# Origination Form

## Proposed Revisions to a Standard Plans Index

<b>Originator:</b>	Turley, Joshua	<b>Index Number:</b>	649-020
<b>Date:</b>	4/17/2024	<b>Sheet Number(s):</b>	3 and 4
<b>E-mail:</b>	Joshua.Turley@dot.state.fl.us	<b>Index Title:</b>	STEEL CCTV POLE

SECTION A-A

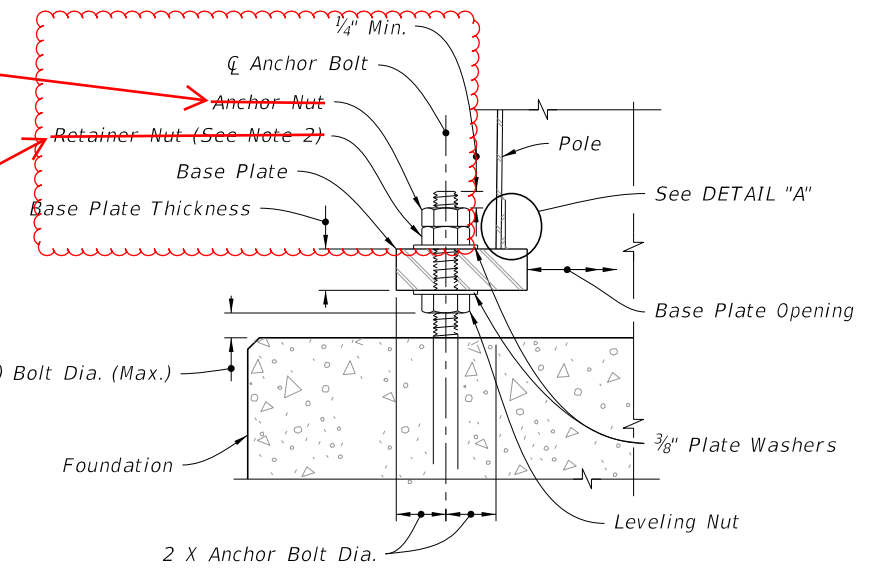
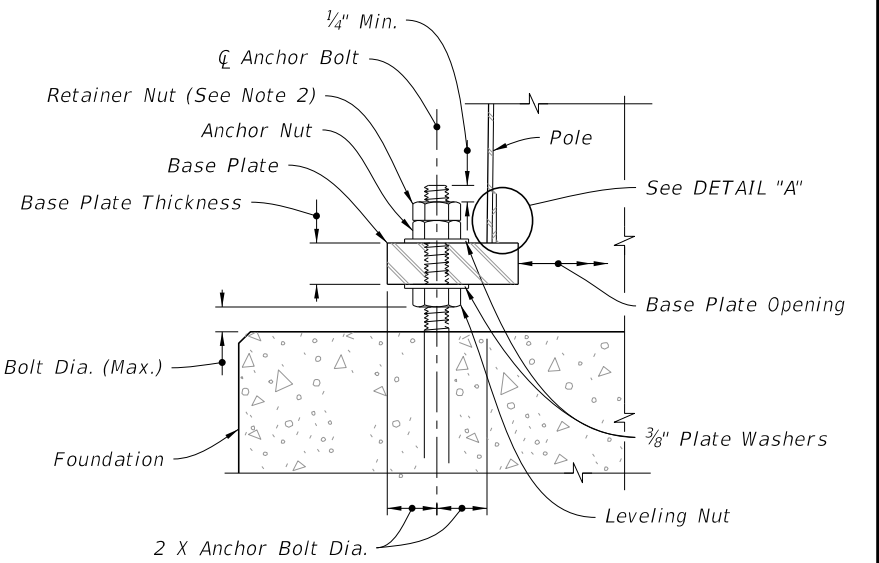
Sheet 3: Section A-A -- Corrected the label order of the anchor bolt nuts; SECTION B-B -- Modified wall thickness from text to symbol. DETAIL A -- Removed weld hatches and modified weld symbol.  
 Sheet 4: FRAME DETAIL -- Modified weld detailing and modified title; SECTION C-C -- Modified weld detailing; Updated callouts and added dimensions to Rod and Eye Bolt Options.

Sheet 3: Anchor nut labels were adjusted to correspond correctly with upcoming associated Spec change being drafted for Section 649; We corrected weld detailing for clarity and brevity.  
 Sheet 4: We corrected weld detailing to conform with accepted convention.

REVISED: Retainer Nut (See Note 2)

REVISED: Anchor Nut
